CITY OF ALBUQUERQUE

RE: Carillo Shop 1001 Old Coors Rd. SW Grading and Drainage Plan Engineer's Stamp Date: 3/16/22 Hydrology File: L11D010

GABINO AND MAGALY CARRILLO SHOP DRAINAGE PLAN/RETENTION POND DESIGN MARCH 2022

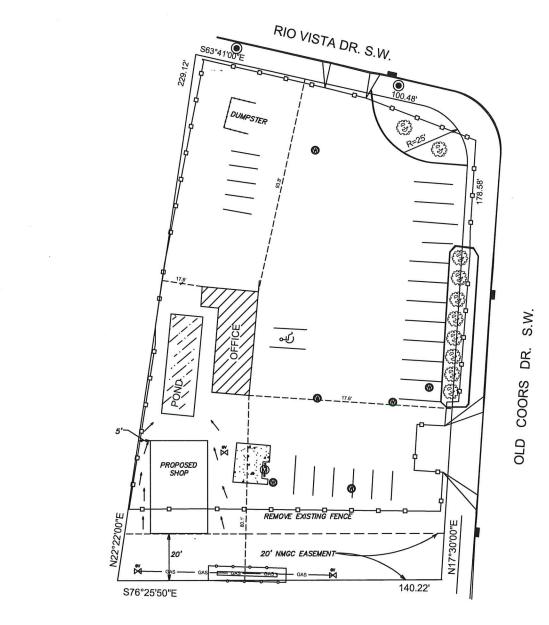
- 1. Please include project benchmark and datum.
- 2. All calculations must be provided and include the data being utilized. (e.g. Total area. Area in each treatment type, proposed vs. existing etc...) This needs to be for the entire lot.
- NM 87103

- 3. Provide calculation for storm water quality needed.
- 4. Please clearly show existing vs. proposed infrastructure/buildings et...
- 5. The proposed shop needs to show the square footage, finished floor elevation.
- 6. Provide survey elevation points.

- 7. The storm is a 1% storm not 90th percentile. Please review the calculations. Are you saying the result is 0.44 inches or is that the intensity?
- 8. Provide a section of the pond showing the elevation.
- 9. Is it a retention pond? If so, it needs to contain the 100-year-10-day storm for the site.
- 10. Please ensure the shop does not encroach into the easement including any footings.
- 11. Please label the scale and utilize 1"=20'
- 12. Please include vicinity map.
- 13. Please include the FIRM and state what zone the site sits in.
- 14. The impervious area being affected with this needs to be summarized.
- 15. Show direction of roof drainage.
- 16. Overall, please take a second look at this and show some detail to explain how the site drains and where this new structure will drain. We also need elevations and survey data.
